Comments on examination documents EX156 to EX159

These comments are made in my capacity as a local resident and landowner and as a member of the Central Herts Green Corridor Group. They focus on Birchall Garden Suburb, the development site proposed in the Welwyn Hatfield draft local plan under policy SP19. Many of my comments relate to the Cole Green landfill site (now long closed) which I personally observed in operation growing up as a neighbour. My comments also need viewing in the light of my 23 years experience working in this locality as a Flood Risk Inspector for the Environment Agency.

RIVER LEE AT HOWE GREEN (WATER HALL)
Ranking used data from 01/04/1959 to 31/12/2017

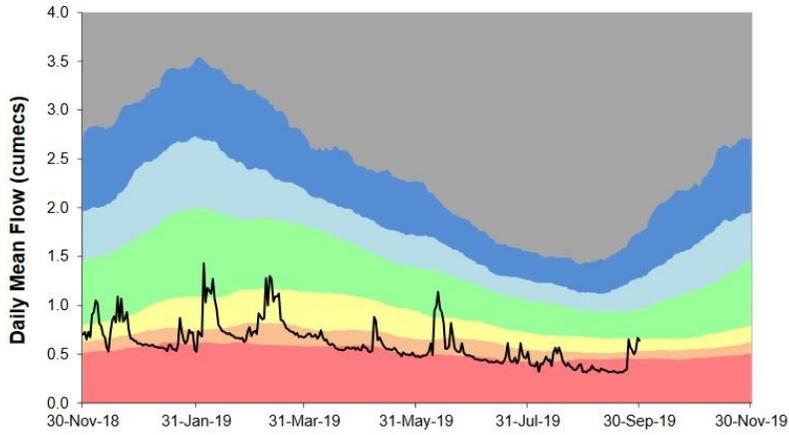
The water environment across the WHBC area has suffered severely this year with record equaling low flow in the River Lee and near record groundwater level falls. We risk catastrophic biodiversity loss if the balance between natural and public water needs is not robustly addressed.
